**Response to Comments**  
**on the**  
**Draft NEWIOU Feasibility Study**

## Response to CIWMB Comments on the Draft Feasibility Study for the NEWIOU

SD037

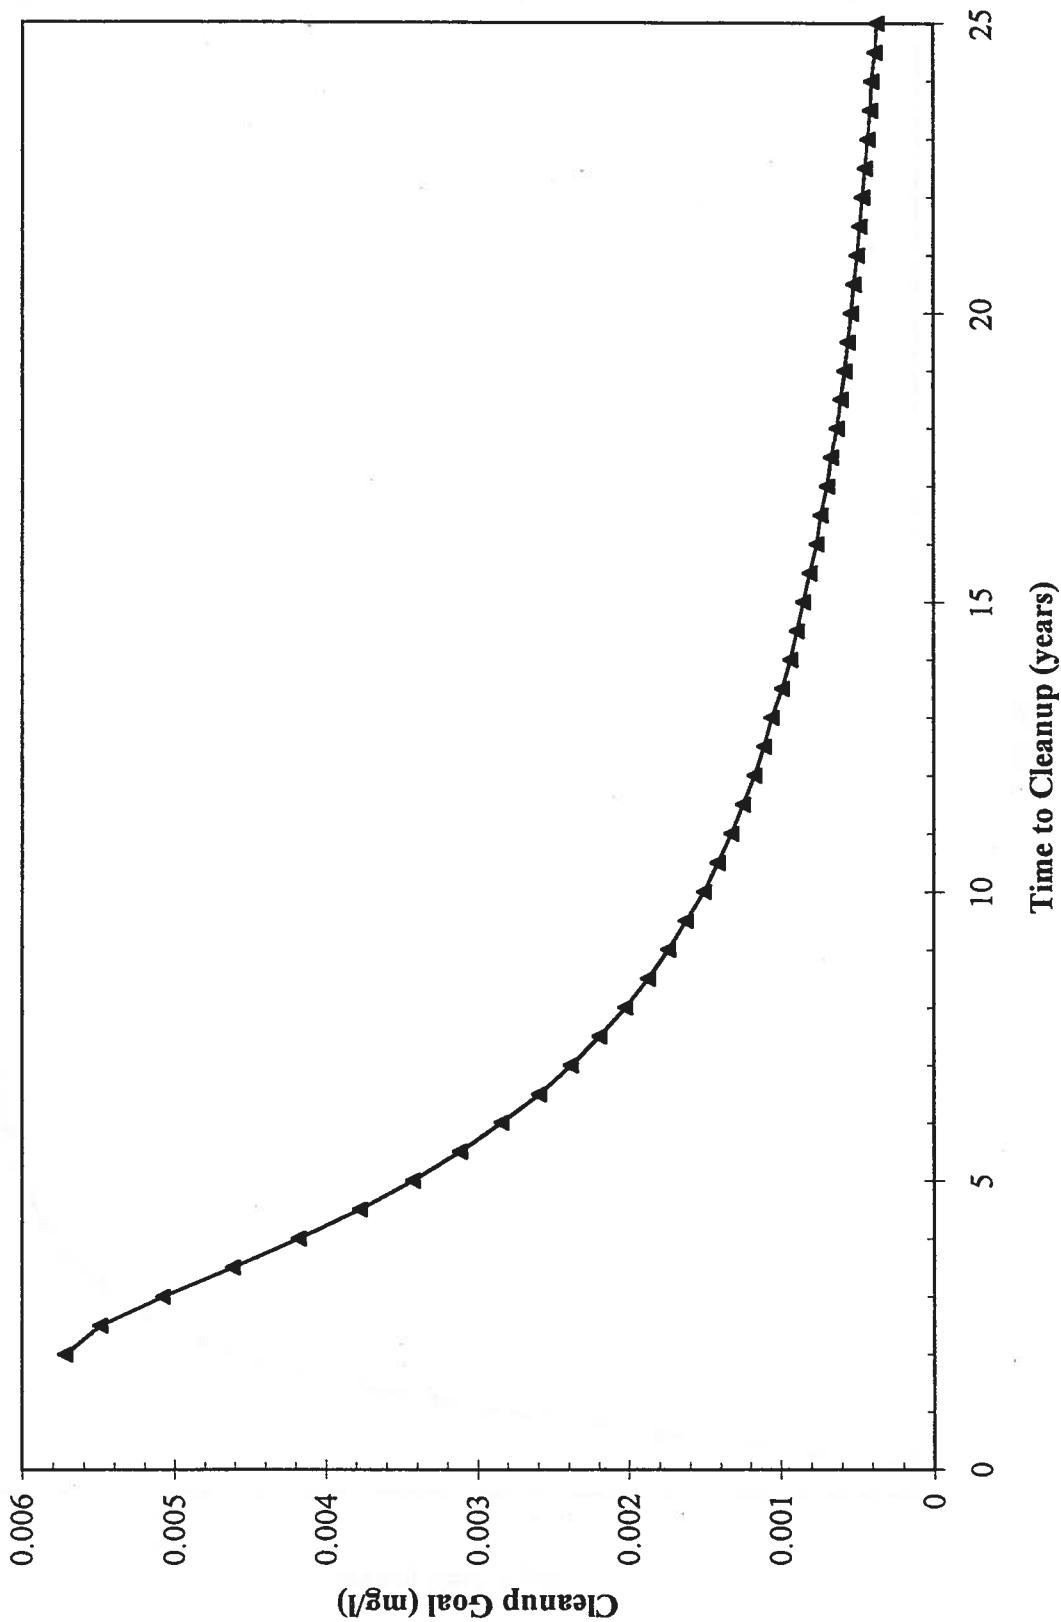
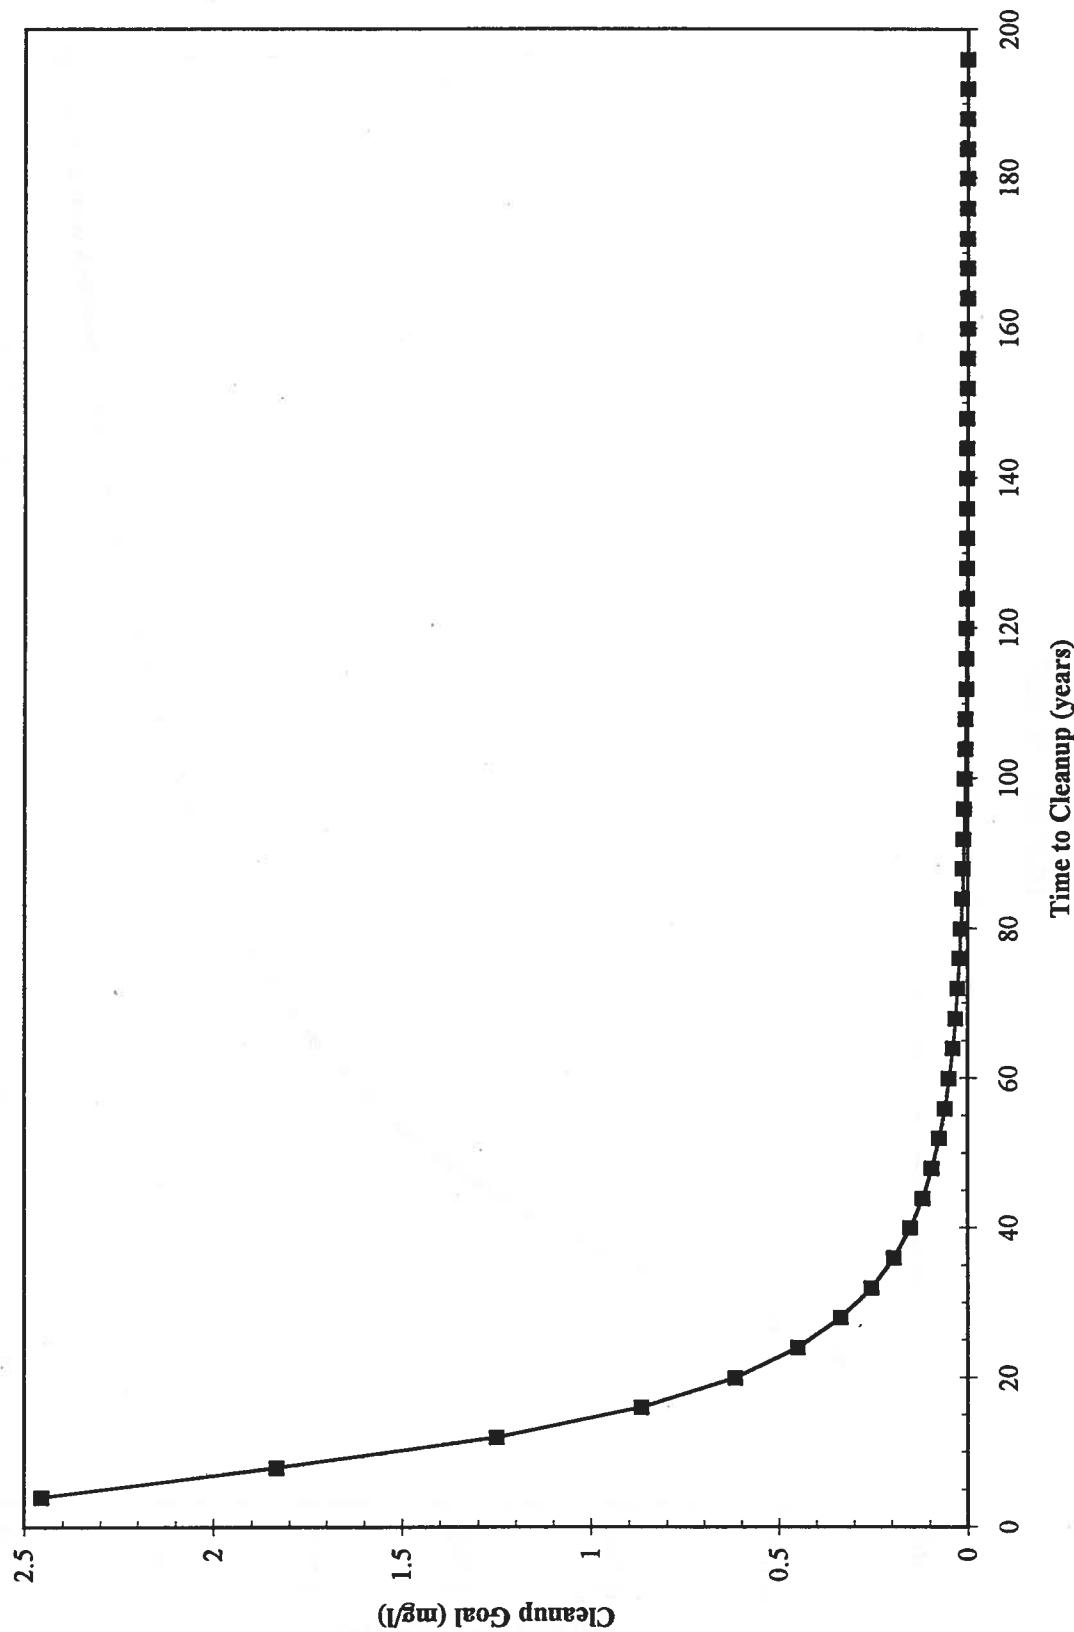
No.	Comments	Responses/Notes
13	<p><b>Appendix C, Time to Cleanup Determination Procedure</b></p> <p><b>Table C-10, Time to Cleanup Results</b></p> <p>For Group A sites, LF007B, LF007C, and LF007D, there is an apparent discrepancy in the calculated time to clean up the corresponding plumes and the relative size of those plumes. For example, the plumes under LF007D and LF007B are larger than the plume under LF007C and yet the calculated clean up time for LF007C is approximately ten times greater than LF007D and LF007B. DTSC recommends that the calculations be redone to check for possible errors. If the calculations are correct, then a discussion is needed to explain why there is such a large variation in cleanup times between LF007C and LF007B/LF007D. Any changes made to this table will also require modification of corresponding figures and discussion in the rest of the report.</p>	<p>The calculations for LF006 and LF007C were incorrect. The times to cleanup LF006 and LF007C should be lower. These times to cleanup have been corrected. In addition, an explanation of the following differences will be added to the Appendix: LF007B and LF007D were modeled based on chlorobenzene, while LF007C was modeled based on TCE, as noted in the summary table. In addition, LF007B and LF007C were modeled for linear flow through the plume, while LF007D was modeled for radial flow from the center of the plume.</p>
